Notification of Product/Process Change

Title of change	Photo interrupter RPI-0 series AI bag packing specifications unification change application	
Affected product(s)	Manufacturer part number	Customer part number
	RPI-0* series	RPI-0226(B105-030-A004)
Detailed description of change	Now	After
	The current situation depends on the model. Unified after change.	① Indicator enclosed ② With MSL notation ③ AI bag without vacuuming
Reason for change	Unification to JEDEC-compliant packaging specifications.	
Anticipated impact on quality	Since only the packing condition is changed, there is no effect on quality and characteristics.	
Identification of change	Can be identified by the shipping lot number.	
Planned first ship date :	December 1, 2022	Sample available schedule Within 8 weeks from request
Attachments (data, report)	YES	4ME4822004.pdf
Comments

Photo interrupter RPI-0 series AI bag packing specifications unification change application

No. 4822004
Mar. 1, 2022
ROHM Co., Ltd.
Module Corporate Headquarters
Module Quality Control Department

Includes Humidity Indicator Card

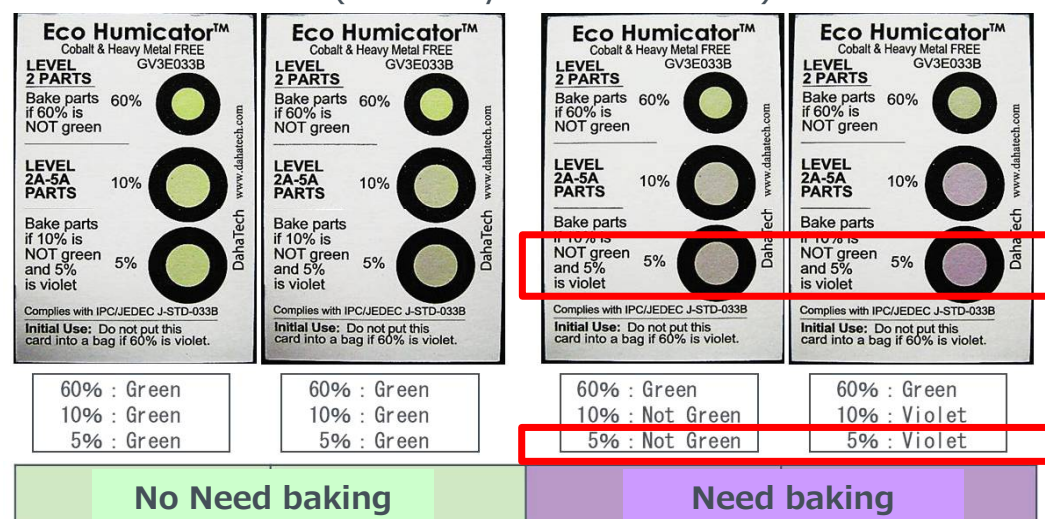
【Purpose of use of HIC】 Judgment material for judging the presence or absence of abnormalities in aluminum packaging.

【How to use】 Check the discoloration state of HIC immediately after opening the aluminum.

If there is something wrong with the aluminum packaging, the HIC display color immediately after opening will be as shown in the red frame on the right of the photo, and baking in the reel state must be carried out.

If the display color of 5% has changed to a color other than green, please perform baking in the reel state at 60°C for 12 hours.
